PIC32MX534/564/664/764 Family Silicon Errata and Data Sheet Clarification

The PIC32MX534/564/664/764 family devices that you have received conform functionally to the current Device Data Sheet (DS60001156H), except for the anomalies described in this document.

The following typographic corrections and clarifications are to be noted for the latest version of the device data sheet (DS60001156H):

FIGURE 1: EXTERNAL COMPARATOR SCHEMATIC EXAMPLE

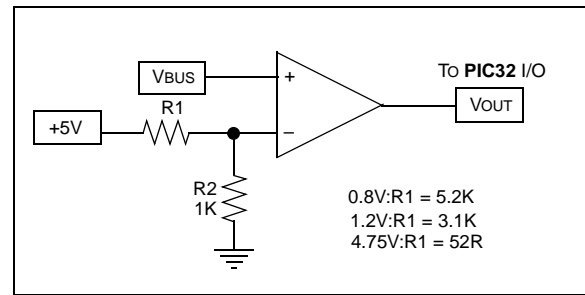
16. Module: USB

When the USB model is configured for OTG operation, it may not recognize all required OTG voltage levels on VBUS pin.

Work around

Use external comparator circuit to detect OTG specific voltage levels on VBUS pin.
